MODIFICATION BULLETIN NO. C-056

ISSUED ON Apr. 22, 1992

Model	FAX 77/80/85/82, infotec 6212/6213/6215, SAVINFAX 301/331, FAX 1040/1045	Date of Modification
Modified Article	PCB Ass'y - SBU	Expected Date
Reason for Modification	<input type="checkbox"/> Parts catalog correction <input type="checkbox"/> To meet standards () <input type="checkbox"/> To facilitate assembly <input type="checkbox"/> Vender change <input checked="" type="checkbox"/> Part standardization <input type="checkbox"/> To improve reliability <input type="checkbox"/> Other	Execution Date
		Effective from the 1st. production of July.
The PCB Ass'y-SBU has been changed to standardize capacitors with other models.

MODIFICATION BULLETIN NO. C-058

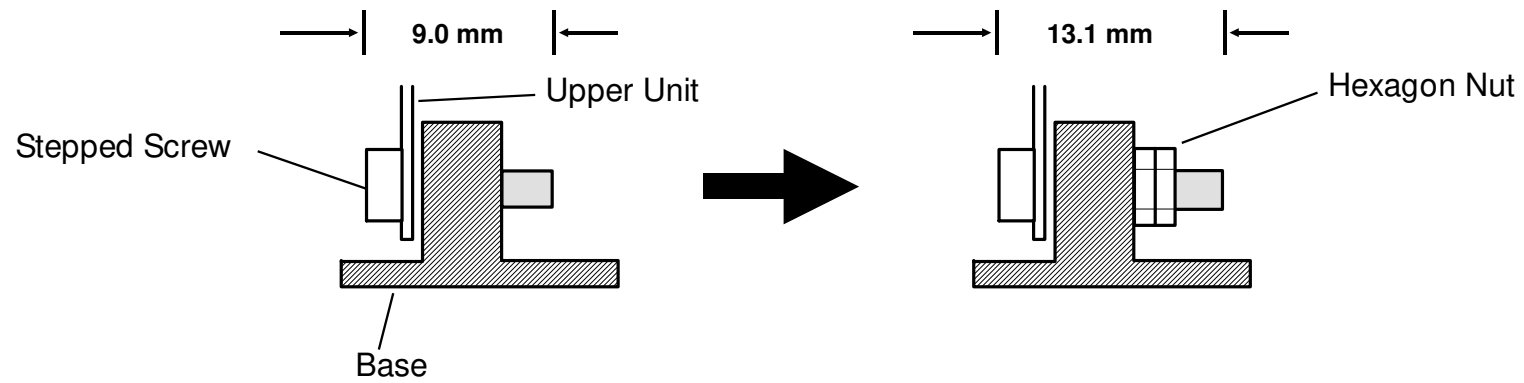
Model	FAX 77/80/85/82, SAVINFAX 301/331, infotec 6212/6213/6215, NASHUA FAX 1040/1045	Date of Modification
Modified Article	Stepped Screw : Printer	Expected Date
Reason for Modification	<input type="checkbox"/> Parts catalog correction <input type="checkbox"/> To meet standards () <input type="checkbox"/> To facilitate assembly <input type="checkbox"/> Vender change <input type="checkbox"/> Part standardization <input checked="" type="checkbox"/> To improve reliability <input type="checkbox"/> Other	Execution Date
		Effective from the 1st. production of August.

Old Part No.	New Part No.	Description	Q'ty Used Old → New	Interchange- ability	Remarks	Parts Catalog	
						Index No.	Page
H0532123A	H0532213	Stepped Screw - M4 : Printer	1-1	X/O		28	1
--	07110040B	Hexagonal Nut - M4	0-1

MODIFICATION BULLETIN NO. C-067

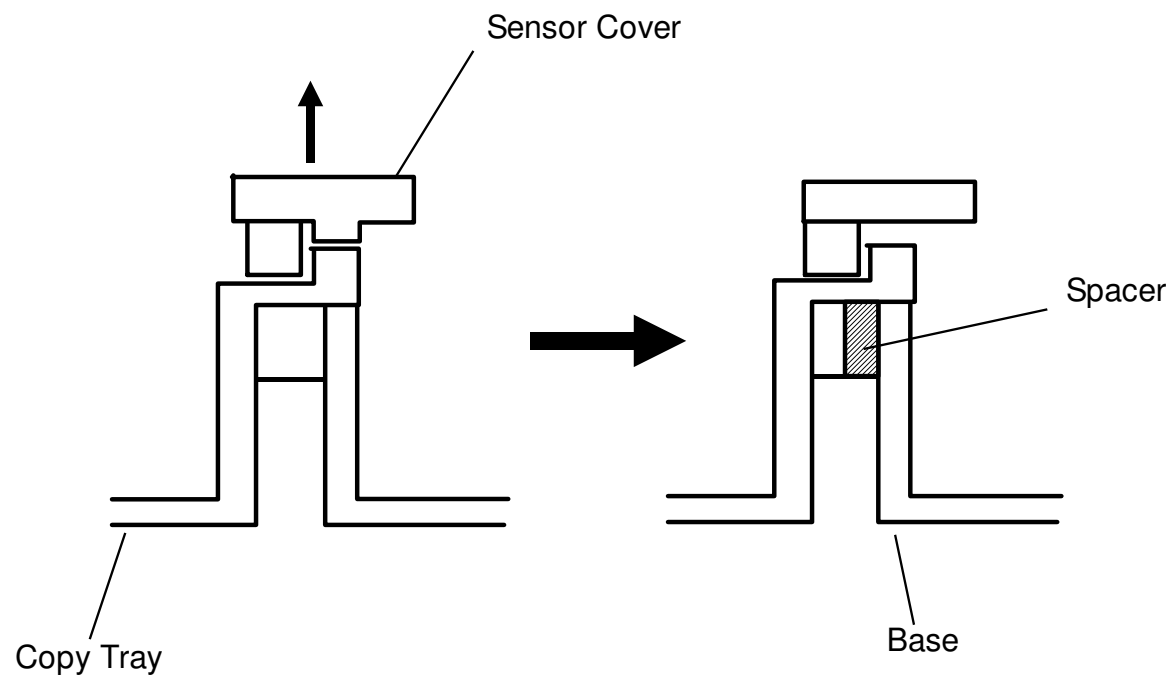
Model	FAX 82					Date of Modification					
Modified Article	Sensor Cover - Feed-out					Expected Date					
Reason for Modification	<div style="display: flex; justify-content: space-between;"> <div> <input type="checkbox"/> Parts catalog correction <input type="checkbox"/> Vender change </div> <div> <input type="checkbox"/> To meet standards () <input type="checkbox"/> Part standardization </div> <div> <input type="checkbox"/> To facilitate assembly <input checked="" type="checkbox"/> To improve reliability <input type="checkbox"/> Other </div> </div> <p>To prevent paper jam, the sensor cover has been changed. When the copy tray is installed, the sensor cover is pushed up by the tray. Then a paper jam might occur.</p>					Execution Date					
						Effective from the 1st. production of August.					
Old Part No.	New Part No.	Description	Q'ty Used Old → New	Interchange- ability	Remarks	Parts Catalog					
						Index No.	Page				
H0542102G	H0542157	Sensor Cover - Feed-out	1-1	X/O							
	H0542158	Spacer - Copy Tray	0 -1								
<div style="display: flex; justify-content: space-between; align-items: flex-start;"> <div style="width: 30%;"> <p>(Asia only)</p> </div> <div style="width: 30%; text-align: center;"> <p>Reference No. for this MB</p> <table border="1" style="margin: auto;"> <tr><td style="padding: 2px;">QECR</td><td style="padding: 2px;"> </td></tr> <tr><td style="padding: 2px;">ECN No.</td><td style="padding: 2px;">91070049 91090017</td></tr> </table> </div> <div style="width: 30%; text-align: right;"> <p>H.Motojima</p> <p>Assistant General Manager</p> </div> </div>								QECR		ECN No.	91070049 91090017
QECR											
ECN No.	91070049 91090017

MODIFICATION BULLETIN NO. C-080

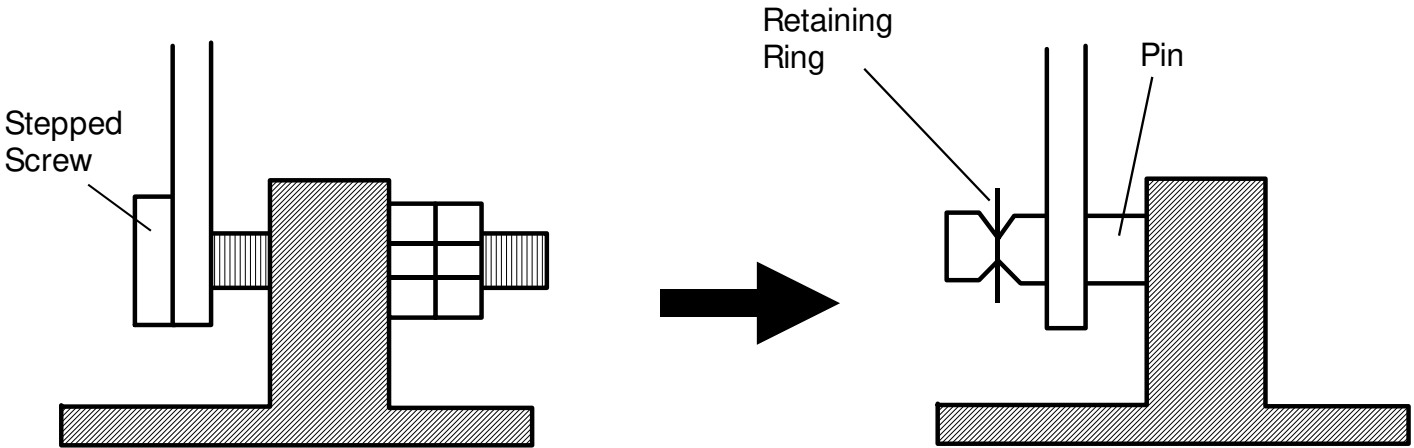
Model	FAX 77/80/85/82, infotec 6212/6213/6215, SAVINFAX 301/331, NASHUA FAX 1040/1045	Date of Modification
Modified Article	Stepped screw	Expected Date
Reason for Modification	<input type="checkbox"/> Parts catalog correction <input type="checkbox"/> To meet standards () <input checked="" type="checkbox"/> To facilitate assembly <input type="checkbox"/> Vender change <input type="checkbox"/> Part standardization <input type="checkbox"/> To improve reliability <input type="checkbox"/> Other	From the 1st production of November.
	The stepped screw and the hexagonal nut for fixing the upper unit on the base have been changed to a retaining ring in order to facilitate assembly.	Execution Date

Old Part No.	New Part No.	Description	Q'ty Used Old → New	Interchange- ability	Remarks	Parts Catalog	
						Index No.	Page
H0532213	--	Stepped screw - M4: Printer	1 - 0			28	1
07110040B	--	Hexagonal Nut	1 - 0				
--	07200050E	Retaining Ring - M5	0 - 1

MODIFICATION BULLETIN NO. C-082ISSUED ON July 7, 1993

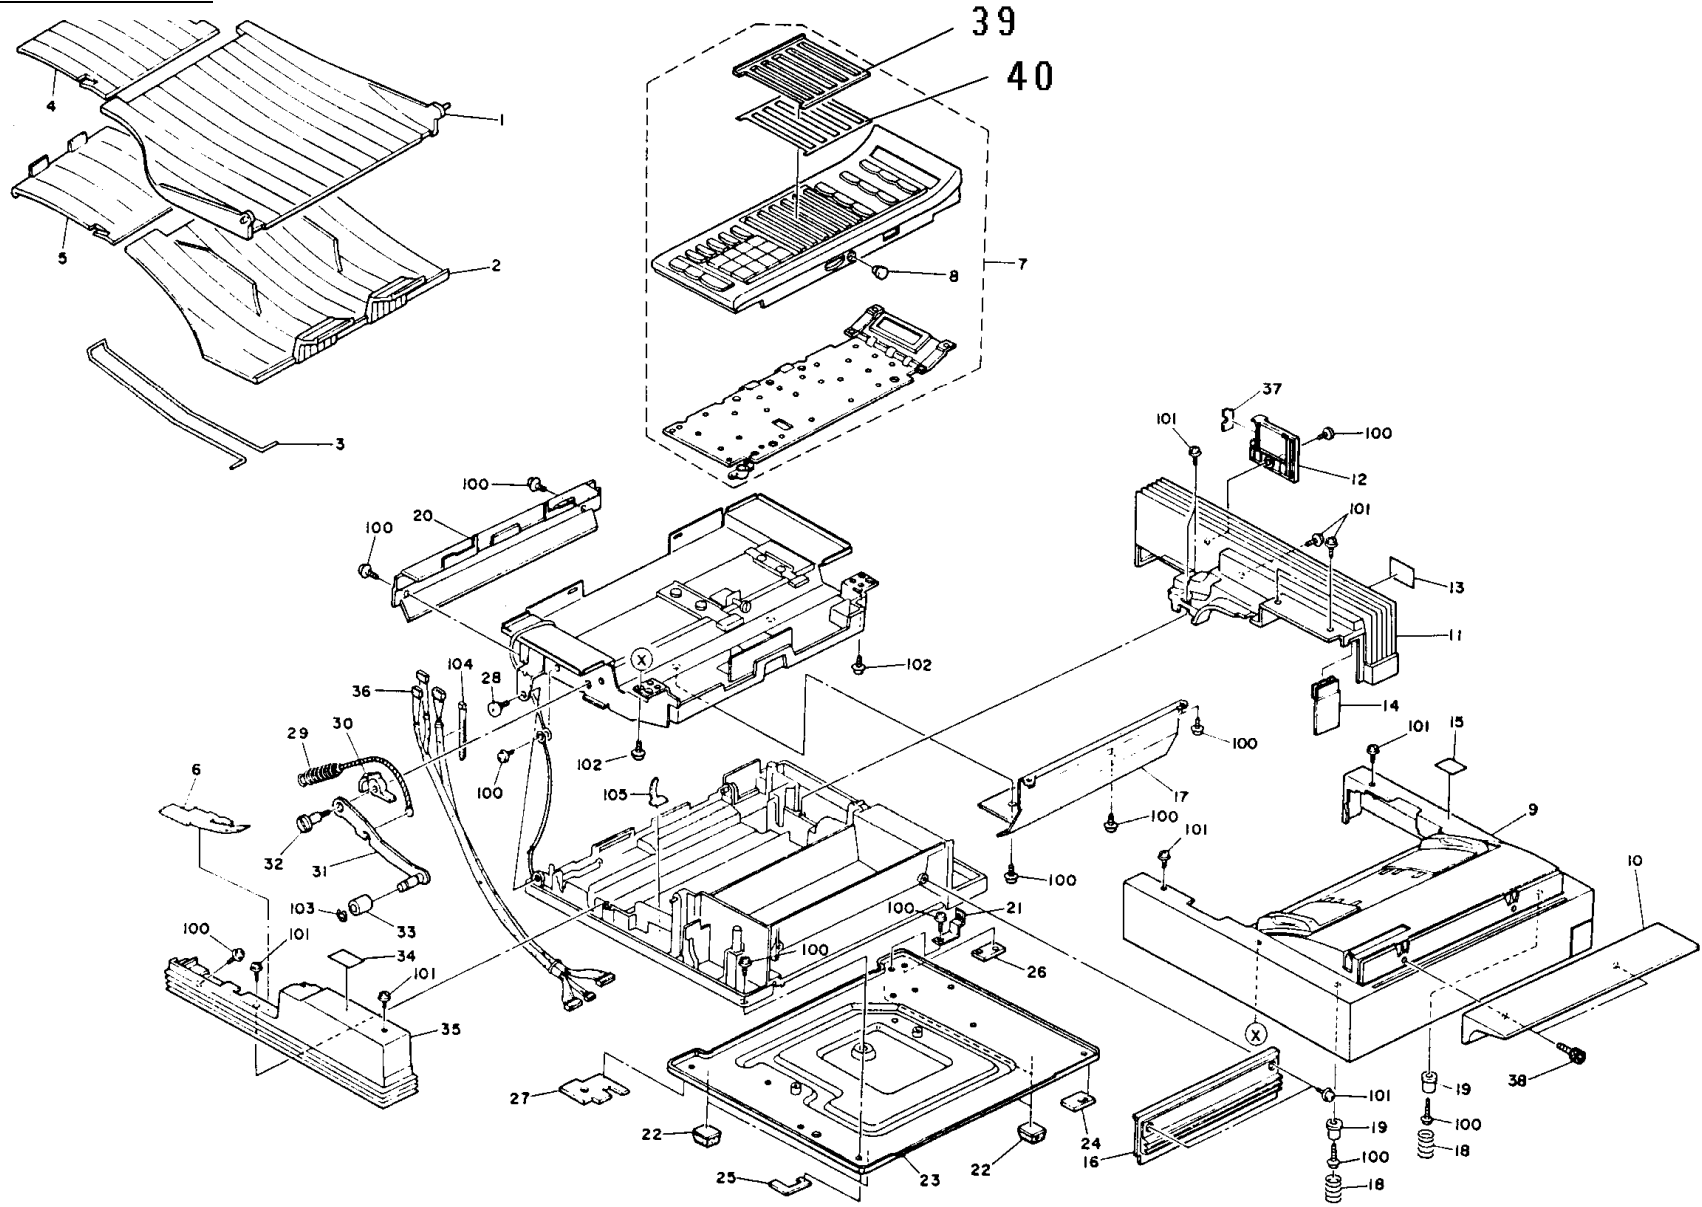
The following parts have been registered as a service part.

Old Part No.	New Part No.	Description	Q'ty Used Old → New	Interchange- ability	Remarks	Parts Catalog	
						Index No.	Page
	H054 3112	Cover - Quick Dial	0 → 1			39	1 - 1
	H054 4313	Quick Dial Sheet	0 → 1			40	1 - 1
	H054 4318	Quick Dial Registration Sheet	0 → 1			40	1 - 1
